**Atari Technical Bulletin**  
**Number: TT30-0006**  
**Date: May 8, 1992**  
**Page 1 of 3**

Product(s) Affected: TT030  
Model: All  
Type of ATB: As Needed  
ECO #: 1451

To correct boot up problems on C302406-001 REV A FAB boards after ATB TT30-0002 or ECO 1425 was applied.

Figure 1

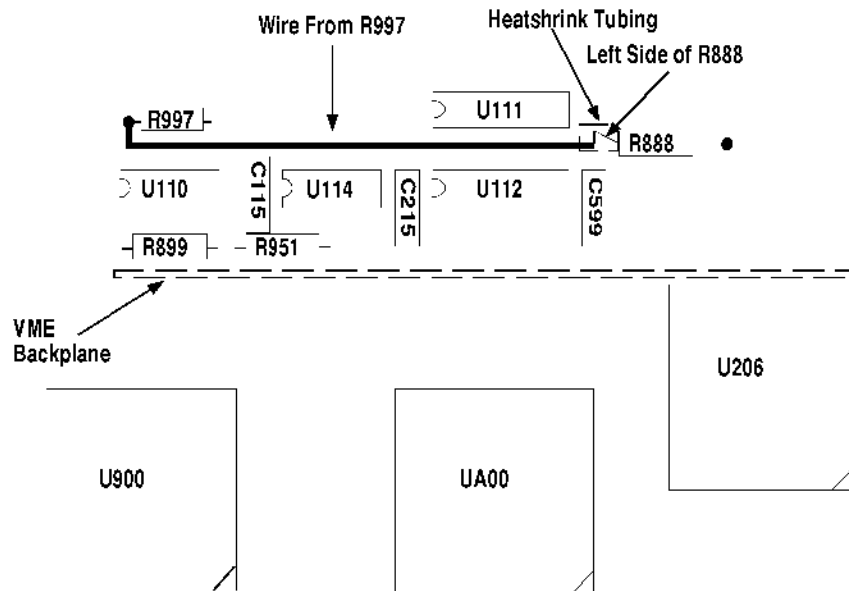
3. If ECO 1425 or ATB TT30-0002 is not installed, skip to step 4. If the first oscillator modification is installed, ECO 1425 or ATB TT30-0002, remove the wire from the left side of R888 and R997. See Figure 1.
4. Lift pins 3 and 17 of U210 so the pins are clear of the pads on the main PCB. See Figure 2.
5. Connect a wire from the right side of R997 to U210 pin 17. See Figure 2.
6. Connect a wire from U210 pin 3 to the left side of R888. See Figure 2.
7. Insulate the connection at R888 with Heatshrink Tubing to guard against any possible shorts. See Figure 2.
8. Re-assemble the unit.
